Our Ref: J27035

28 February 2011

ESKOM ENVIRONMENTAL IMPACT ASSESSMENT (EIA:12/12/20/944) FOR A PROPOSED NUCLEAR POWER STATION AND ASSOCIATED INFRASTRUCTURE: COMMENTS ON THE DRAFT ENVIRONMENTAL IMPACT ASSESSMENT REPORT

Figure 1: Comparison of life-cycle greenhouse gas emissions of different electricity generation systems (Dones et al. 2003)

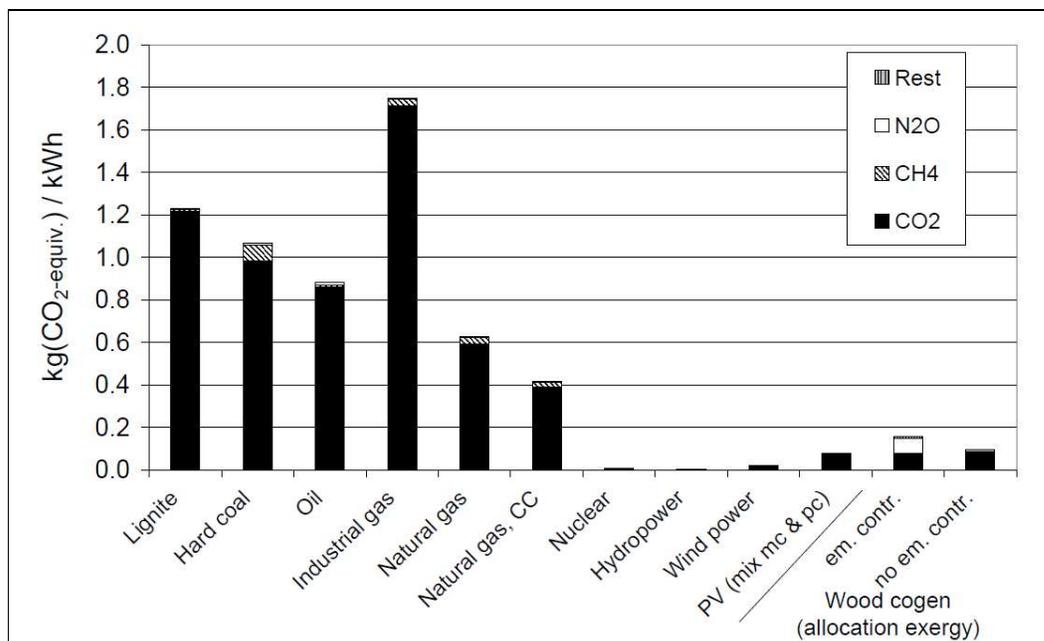
The current drive for development of nuclear is based on the suggestion that nuclear is a favourable technology in view of climate change concerns. This despite the fact that nuclear is not identified in the Kyoto protocol on climate change as a preferred alternative. The motivation in this context of nuclear is accordingly highly suspect.

Section 4.2.2 of the Revised Draft EIR contains a brief comparison of the life cycle greenhouse gas emissions of a number of different generation options, including nuclear, solar, wind and coal-fired generation. A life cycle analysis of the greenhouse gas emissions of these generation options indicates that nuclear power emits less than 11 grams of carbon equivalent per kilowatt-hour (gCeq/kWh) (Dones et al. 2003¹). This is the same order of magnitude as wind and solar power. This is also two orders of magnitude below (i.e. one hundredth of) the average for coal, oil, and natural gas. Apart from the benefit of lower greenhouse gas emissions, nuclear power generation does not emit sulfur dioxides (SOx), nitrous oxides (NOx) and requires much less water than coal-fired power stations. The figure below illustrates the rates at which different generation alternatives emit greenhouse gases.
